File No.: 2026-099

Re: **Request for Access to Records under the Freedom of Information and Protection of Privacy Act (the "Act")**

The following records for 2212 W 10th Avenue:

Title: Land Administration and Planning - Rezoning - Rezoning Enquiry Case Files - 2202-2212 W 10th Ave - Rezoning Enquiry - PS-2024-00001

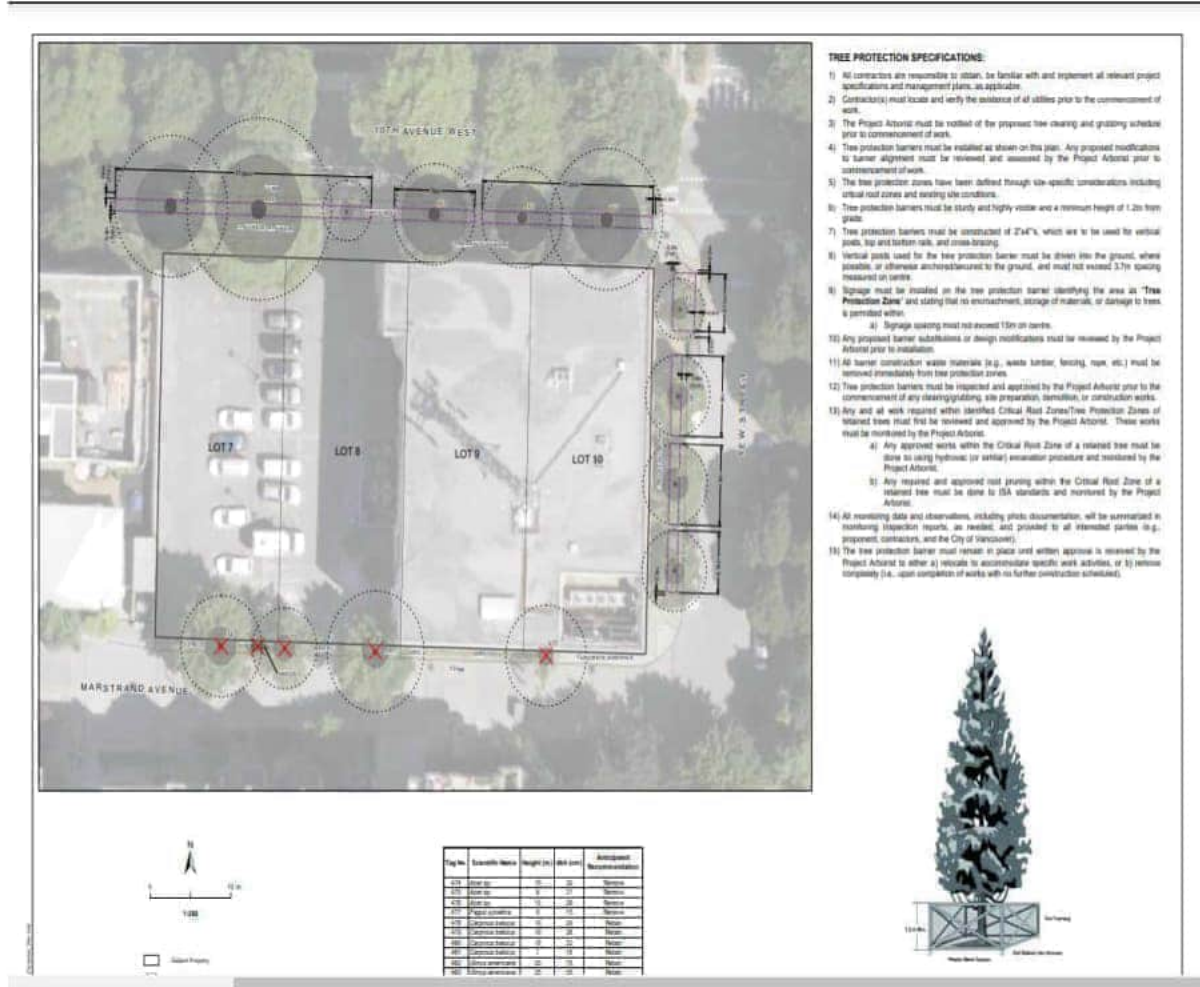
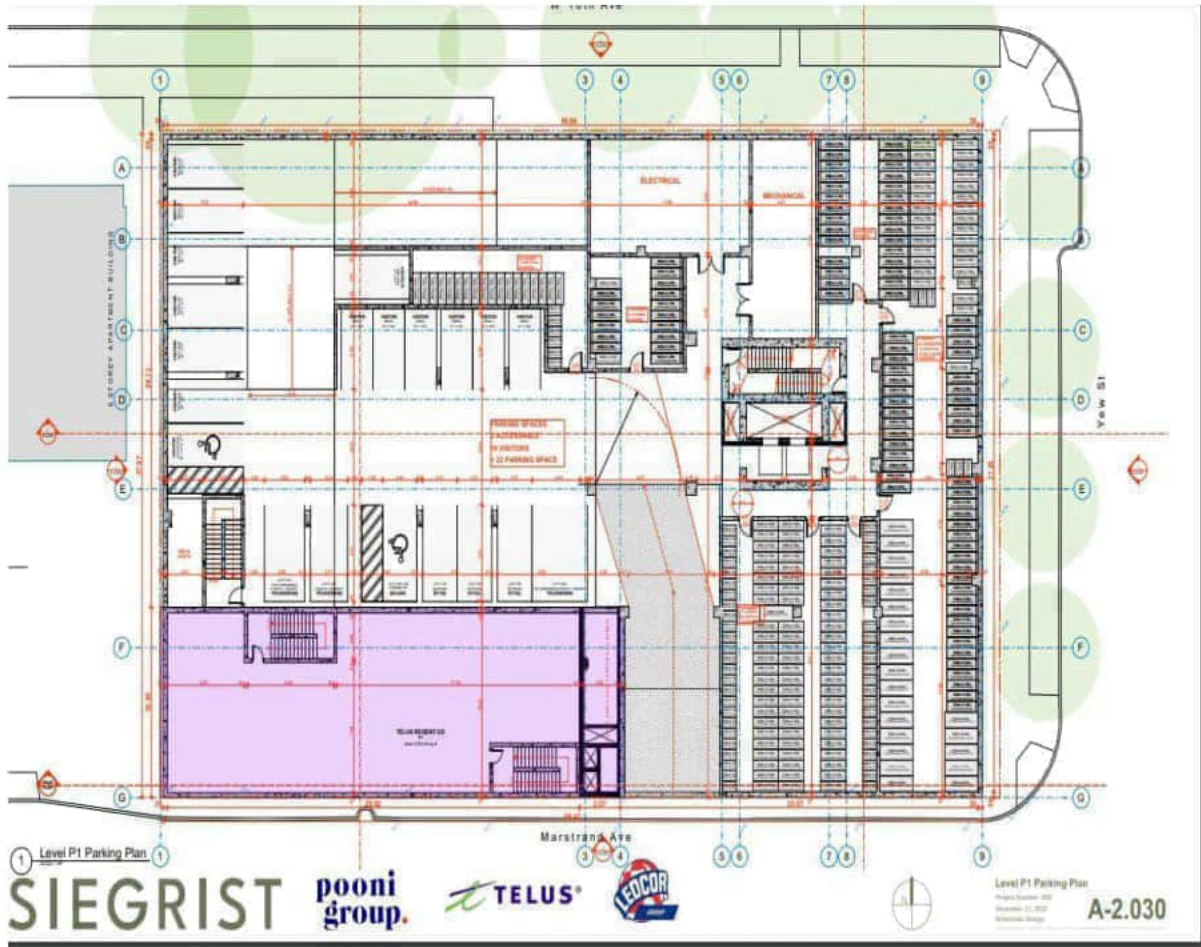
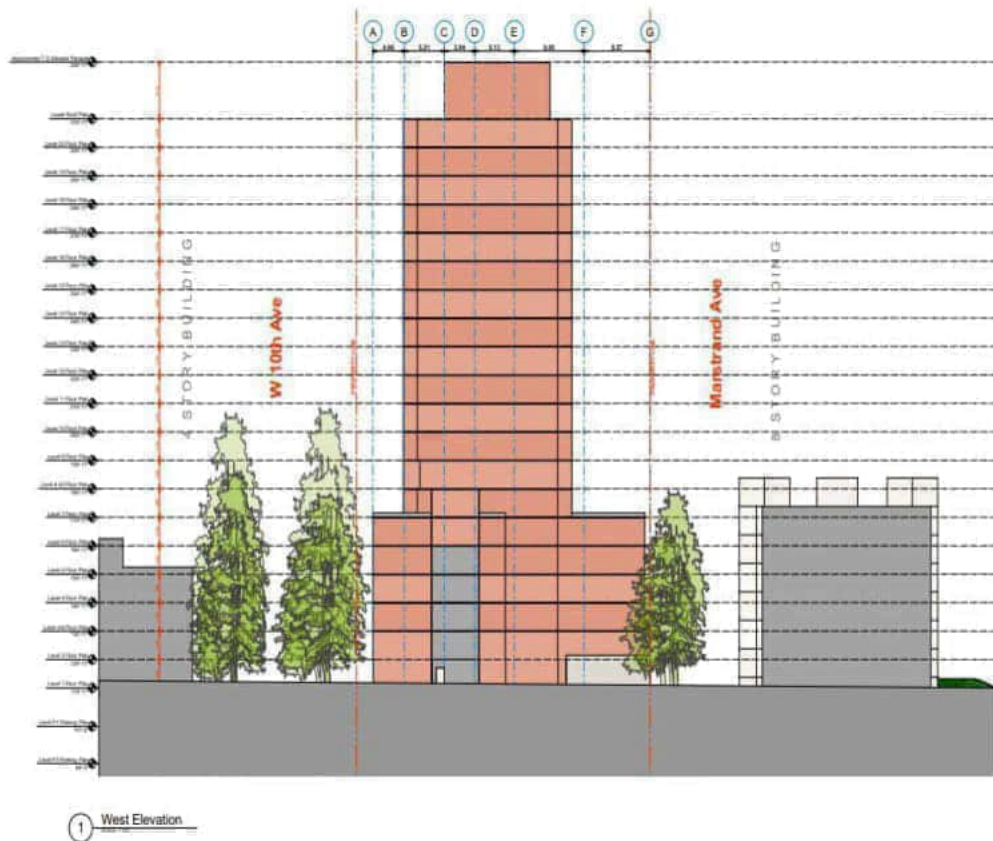
I did not see any evidence in the report that they carried out any root mapping.

The canopies may also conflict with the future building façade, since the existing canopy extends into the site.
